UNITED STATES PATENT AND TRADEMARK OFFICE

10/550,404

Office Action Summary	Application No. 10/550,404	Applicant(s) TEICHNER ET AL.	
	Examiner JASON HOLLOWAY	Art Unit 3633

DETAILED ACTION

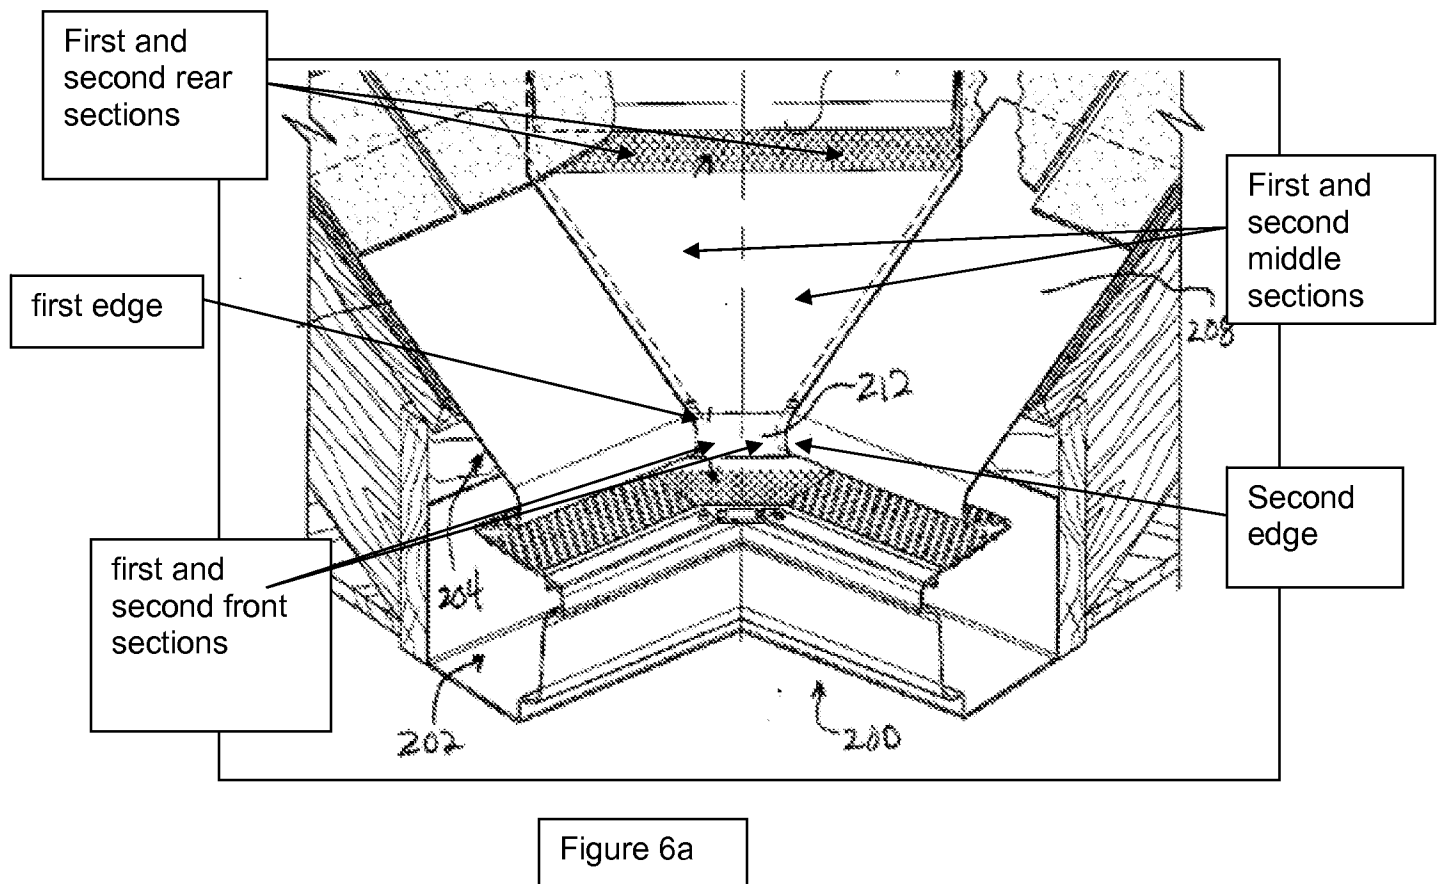
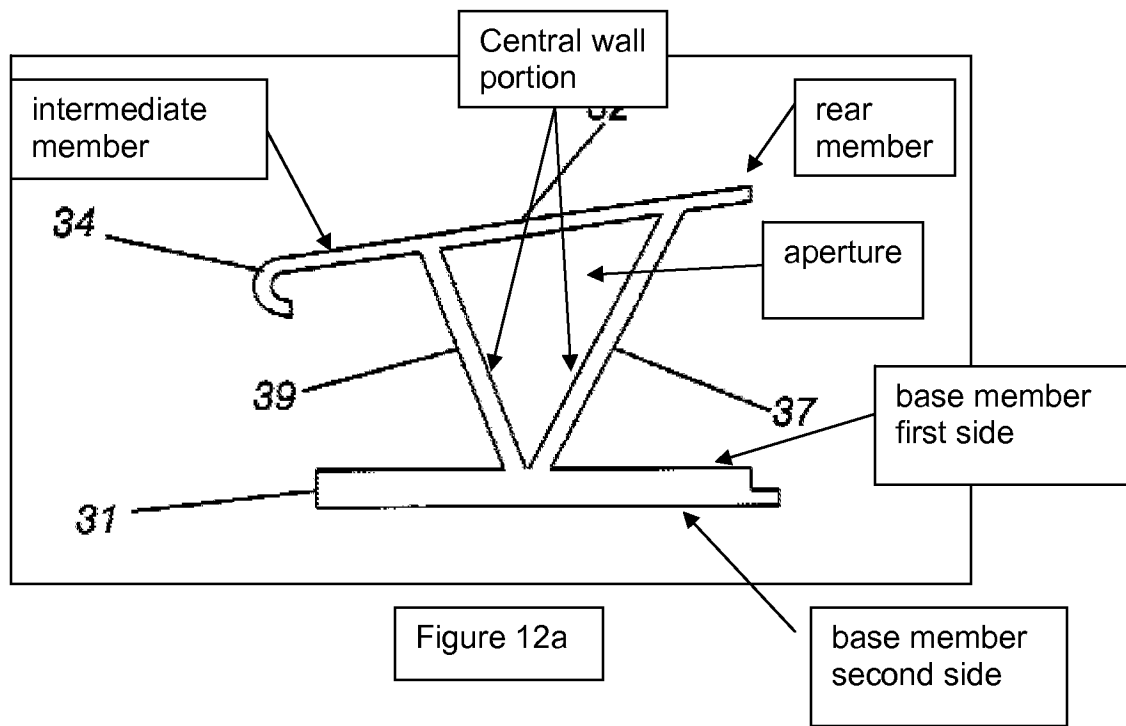
and a first and second edge (first and second members are labeled in examiner amended figure 6a following this action), wherein the first and second front sections are capable of engaging and cooperating with the lip section (as illustrated in figure 6 and 6a, the front sections cooperate with the equivalent lip sections of the gutter covers of Seise), and wherein the first and second edges form first and second channels capable of receiving an edge of the first and second gutter covers (a channel is formed in the first and second front sections of the mullion which accepts the edges of the gutter covers); and

wherein the first half and the second half are joined at an angle relative to one another (as illustrated in figures 6 and 6a, the first and second halves are joined at an angle); and

wherein the corner mullion is positioned between the two gutter covers (cover assembly 204), which are adjacent and at an angled relation to one another (as illustrated in figures 6 and 6a, the two gutter covers are adjacent to one another).

Therefore, from the teaching of Seise, it would have been obvious to one of ordinary skill in the art at the time the invention was made to provide the gutter cover of Richard to include an appropriately fitting corner connecting piece as taught by Seise in order to provide an intermediate piece to connect gutter covers at building corners.
